# Access Compliance Report

## Public Rights-of-Way

### (Curb Ramps)

Intersection ID: 3131	Main Street: SANDMAN_LN	Cross Street: WALDEN_RIDGE_DR	Location: W
ADA ID: CCFCE6D0BFA0	Ramp Type: BlendTrans1	Initial Pass/Fail: Fail	Overall Compliance: No
		Severity Score: 8.75

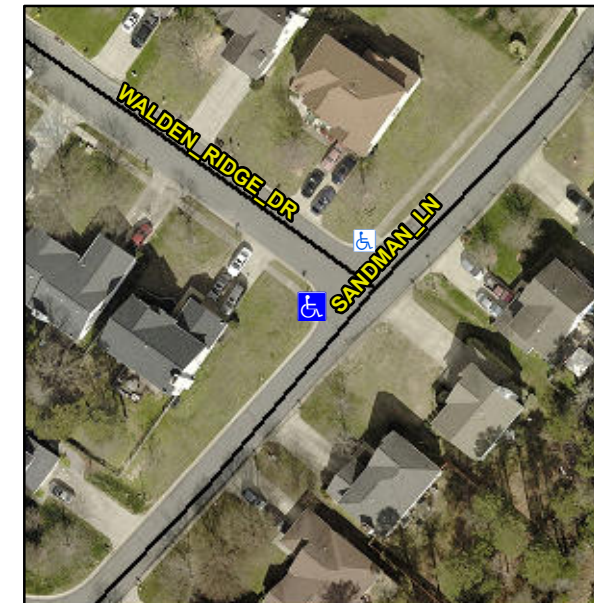
**Not Found, R304.5.1**

Compliance	Description	Data	Compliance	Description	Data
N/A	Ramp Length (in)	49.0	Yes	BlendTrans Slope (%)	3.3
No	Ramp Width (in)	47.0	Yes	BlendTrans XSlope (%)	0.0
N/A	Flare Type LT	N/A	N/A	Flare Type RT	N/A
N/A	Flare Slope LT (%)	N/A	N/A	Flare Slope RT (%)	N/A
N/A	Flare Traversable LT?	N/A	N/A	Flare Traversable RT?	N/A
N/A	Landing Length (in)	N/A	N/A	DWS Provided?	N/A
N/A	Landing Width (in)	N/A	N/A	DWS Contrast?	N/A
N/A	Landing Slope (%)	N/A	N/A	DWS Length (in)	N/A
N/A	Landing X Slope (%)	N/A	N/A	DWS Full Width?	N/A
N/A	Landing Curb? (Y/N)	N/A	N/A	DWS Offset (in)	N/A
N/A	Shared Landing?	N/A			
N/A	Gutter Ponding?	N/A	N/A	Gutter Slope (%)	N/A
N/A	Gutter Lip Ht (in)	N/A	N/A	Gutter X Slope (%)	N/A
N/A	Painted X Walk1?	No	N/A	Painted X Walk2?	N/A
	X Walk 1 Direction	To NE		X Walk 2 Direction	N/A
	X Walk 1 Width (in)	N/A		X Walk 2 Width (in)	N/A
	X Walk 1 Slope (%)	2.8		X Walk 2 Slope (%)	N/A
	X Walk 1 X Slope (%)	4.6		X Walk 2 X Slope (%)	N/A

N/A	Ramp inside XWalk1?	N/A	N/A	Ramp inside XWalk2?	N/A
	Road Slope (%)	4.6		Clear Space?	N/A
	Road X Slope (%)	2.8	N/A	Clear Space to XWalk (in)	N/A
N/A	Any Obstructions?	N/A	N/A	Storm Grate/Utility Hazard?	N/A
	Obstruction Type			Storm Grate/Utility Type	
		N/A			N/A
			Yes	Surface Condition? (G/P)	Good
			No	Curb Slope (%)	18.2

**Remove & Replace Curb Ramp With Two New Directional Ramps or Equivalent.**
